Rozelle Interchange Urban Design and Landscape Plan: Community consultation feedback and response overview

June 2021

Figure 4-5: EIS Design compared with UDLP

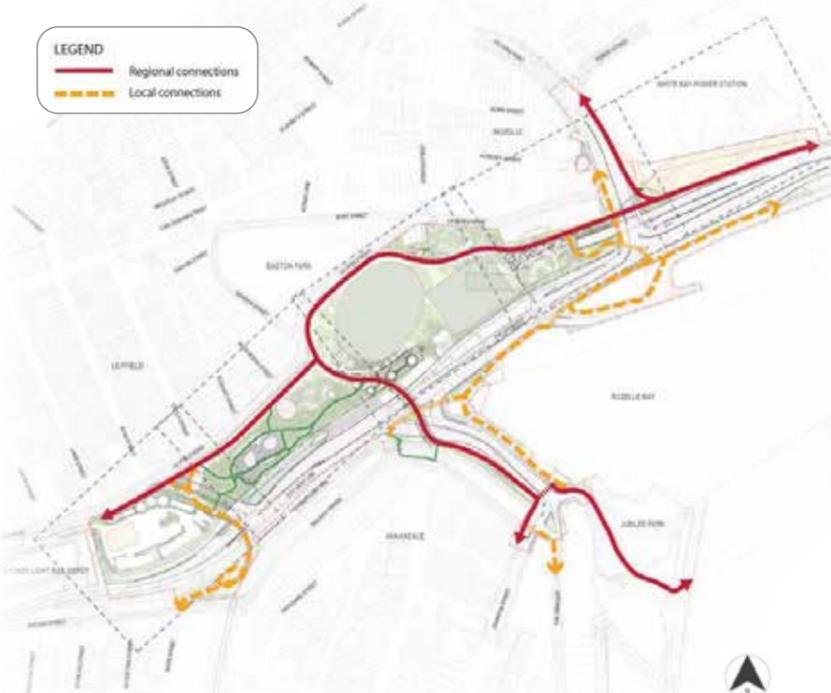
A significant number of community comments requested design changes to the ventilation outlets at both Rozelle Parklands and Iron Cove Link. Some suggestions included cladding the outlets in sandstone or incorporating a mural to represent the Aboriginal heritage of the area.

In relation to the Rozelle Parklands ventilation facilities, the UDLP design is a significant improvement to the initial design proposed in the Environment Impact Statement (EIS) submitted in 2017. We have been able to move ventilation supporting structures underground to free up a significant new area of green space above ground.

The design of the ventilation facilities was undertaken by our expert designers and endorsed by the DRP. It is not proposed to change the design of the Rozelle Parklands ventilation outlets.

Figure 6: Cycling and pedestrian paths map

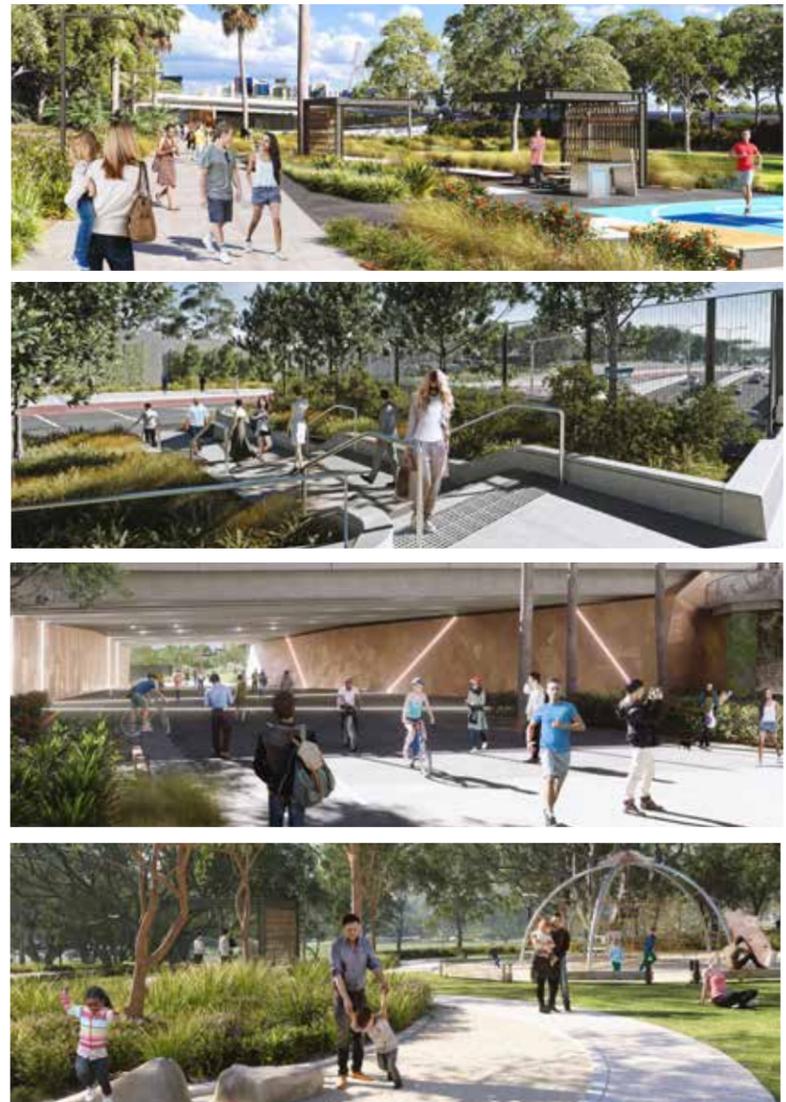
Prior to the exhibition of the UDLP the project consulted with bicycle groups and other users regarding shared user paths. A number of submissions suggested that pedestrian and cyclist paths be separated by a physical structure. The shared user path is proposed to be a five metre wide path through the parkland with line-marking for improved safety and usability. The illustration from the UDLP in Figure 6 (left) did not include the proposed line-marking.

This is being addressed by the Rozelle Parklands Working Group for further consideration.
